**Levy Nuclear Plant Units 1 and 2 (LNP)
Updated Response to NRC Request for Additional Information Letter 126 Related to
Standard Review Plan Sections 6.4, Control Room Habitability and 16, Technical
Specifications, dated May 13, 2015**

NRC Letter No.: LNP-RAI-LTR-126

NRC RAI NUMBER: 06.04-5

DEF RAI ID#: L-1167

Figure 3D-201, Typical Abnormal Environmental Test Profile:
Main Control Room

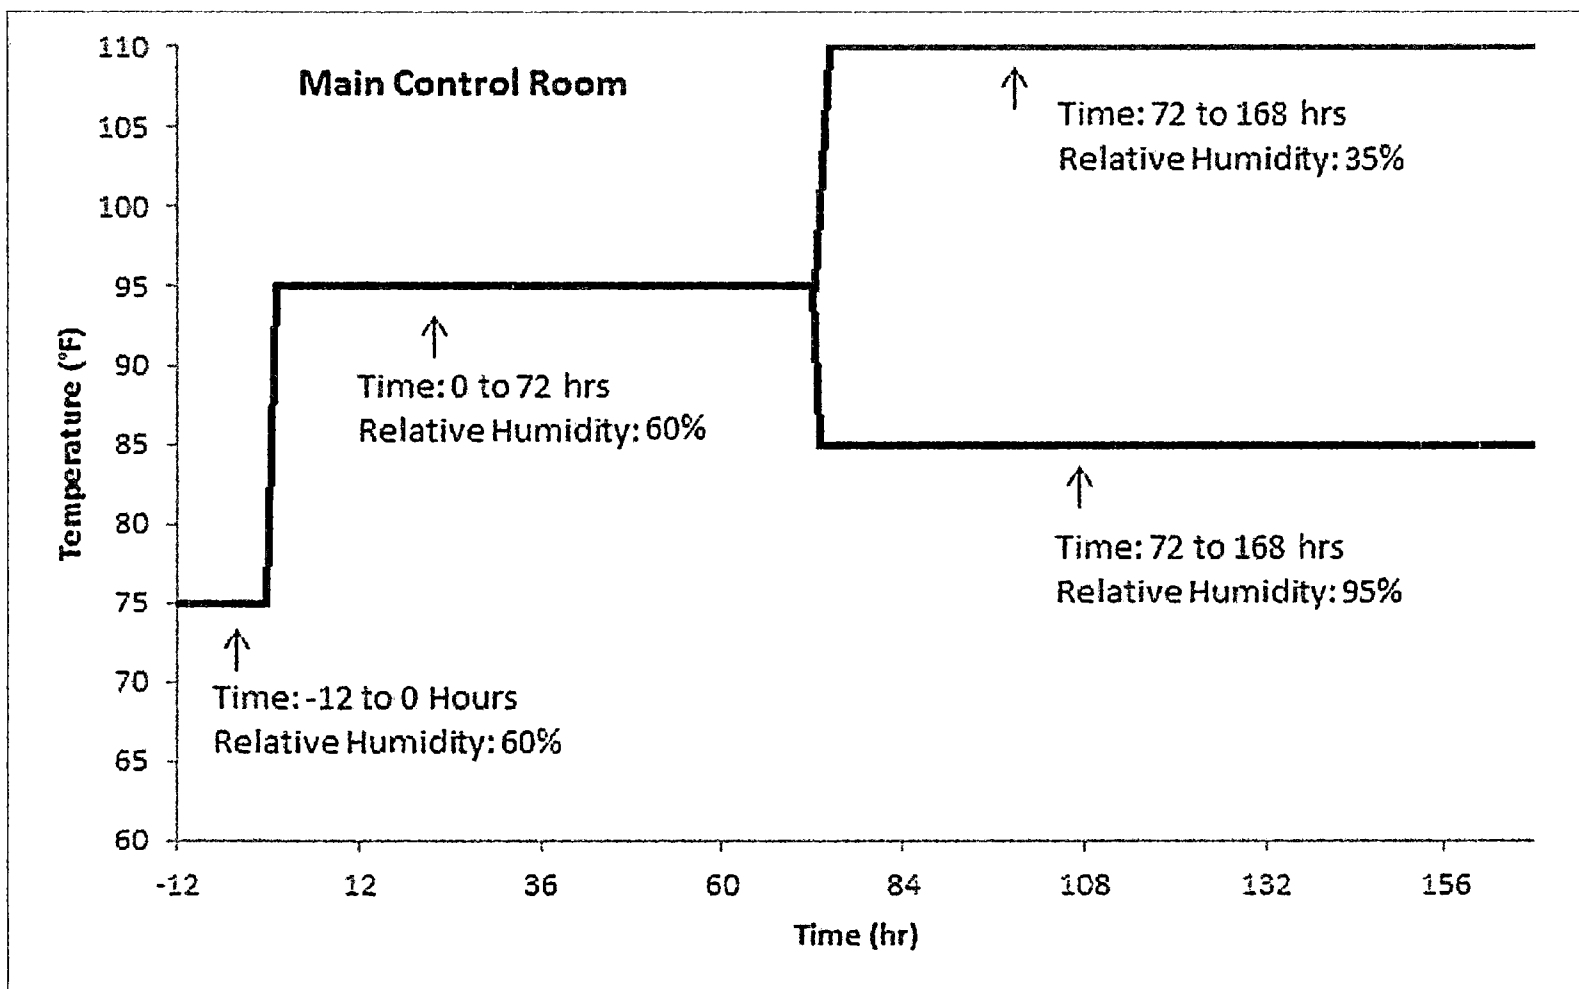
Please clarify the temperature and humidity limits you are proposing for the MCR ancillary fans (those in Figure 3D.5-1 or those in Figure 3D-201).

The limits shown in Figure 3D-201 suggest that MCR conditions in the Post-72 period following an accident could reach 115°F dry bulb temperature with 35% relative humidity (RH). In this regard, please provide the following and include a reference to this information:

Figure 3D-201 of the previous response to NRC question 06.04-5 contained an error. This updated response replaces the original Figure 3D-201 provided in COLA change number 2 (Enclosure 1, page 4 of 7) in DEF Letter Serial NPD-NRC-2015-049, submitted to the NRC on November 12, 2015.

1. COLA Part 2, FSAR Appendix 3D, will be revised to add a departure from DCD Figure 3D.5-1, Typical Abnormal Environmental Test Profile: Main Control Room, Sheet 1 of 3, as new FSAR Figure 3D-201 with a LMA of LNP DEP 6.4-2. This Figure shall also be added to the list of figures in Chapter 3. Figure 3D-201 is shown below.
